HOSHIZAKI AMERICA, INC.

SERVICE BULLETIN

SB15-0001

SUBJECT: 4A1322-01 (RS70C1E-PFV) COMPRESSOR CHANGE

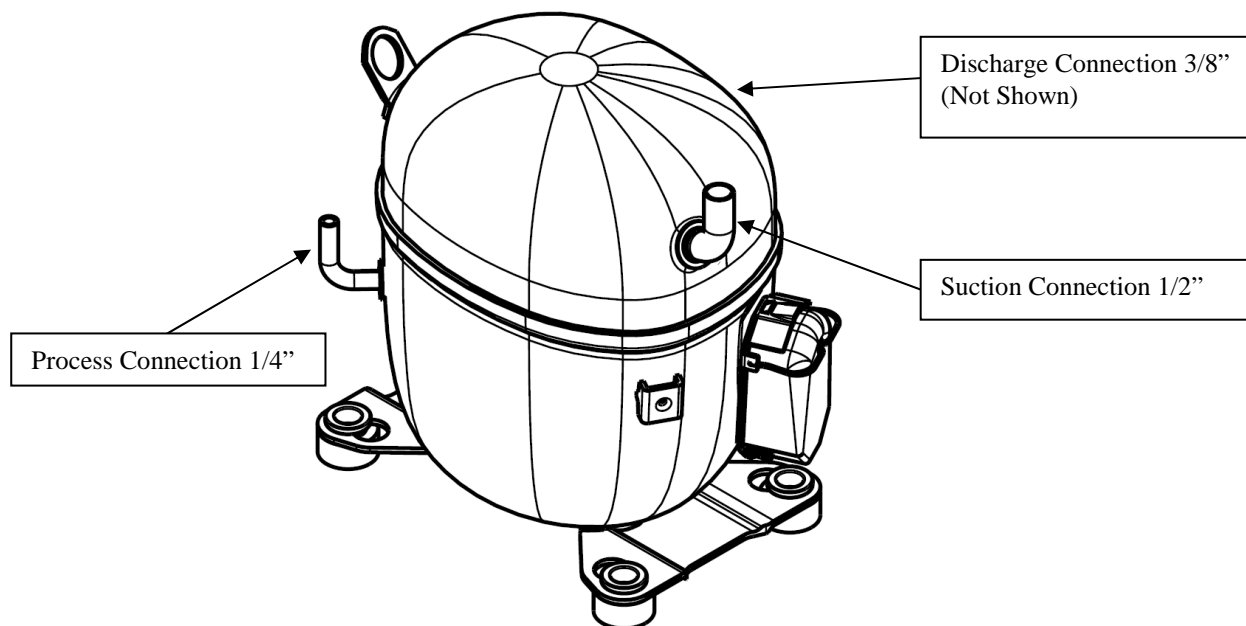
Although the footprint and the mounting of the compressors will be the same, this change will require connecting different size tubing and re-routing refrigerant lines. The suction fitting was 5/8" and is now 1/2", the process tube fitting was 3/8" and is now 1/4" and the discharge fitting remains 3/8". Use standard refrigeration practices to make the reduced connections. You may also have to lengthen the compressor leads during the changeover. See below for location of the ports on the replacement compressor.
